Access Compliance Report

Public Rights-of-Way

Intersection ID: 49356	Main Street: CONSERVATORY_LN	Cross Street: SULKIRK_RD	Location: W
ADA ID: 99D83BDC8824	Ramp Type: PerpDiag	Initial Pass/Fail: Pass	Overall Compliance: No
			Severity Score: 15.25

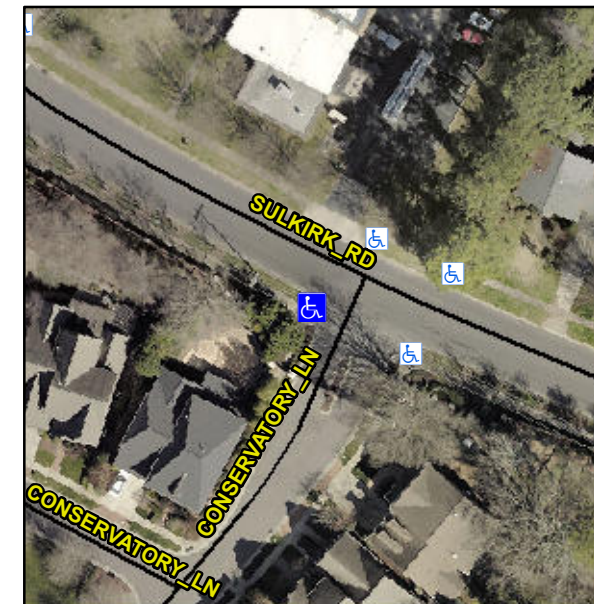
Not Found, R304.5.3, R304.2.1, R304.2.2-Perp, R304.3.2-Para, R305.2, R304.5.4

Compliance	Description	Data	Compliance	Description	Data
N/A	Ramp Length (in)	121.0	Yes	Ramp Slope (%)	6.4
Yes	Ramp Width (in)	49.0	No	Ramp XSlope (%)	4.1
N/A	Flare Type LT	Sloped	N/A	Flare Type RT	N/A
N/A	Flare Slope LT (%)	4.4	Yes	Flare Slope RT (%)	8.5
N/A	Flare Traversable LT?	Yes	N/A	Flare Traversable RT?	Yes
No	Landing Length (in)	N/A	Yes	DWS Provided?	Yes
No	Landing Width (in)	N/A	Yes	DWS Contrast?	Yes
No	Landing Slope (%)	N/A	Yes	DWS Length (in)	24.0
No	Landing X Slope (%)	N/A	Yes	DWS Full Width?	Yes
N/A	Landing Curb? (Y/N)	No	No	DWS Offset (in)	2.5
N/A	Shared Landing?	N/A			
Yes	Gutter Ponding?	No	No	Gutter Slope (%)	7.3
Yes	Gutter Lip Ht (in)	0.0	Yes	Gutter X Slope (%)	1.3
N/A	Painted X Walk1?	No	N/A	Painted X Walk2?	No
	X Walk 1 Direction	To SE		X Walk 2 Direction	To NE
N/A	X Walk 1 Width (in)	N/A	N/A	X Walk 2 Width (in)	N/A
	X Walk 1 Slope (%)	1.5		X Walk 2 Slope (%)	3.3
	X Walk 1 X Slope (%)	5.4		X Walk 2 X Slope (%)	1.1

Remove & Replace Curb Ramp With Two New Directional Ramps or Equivalent. Remove & Replace Gutter.
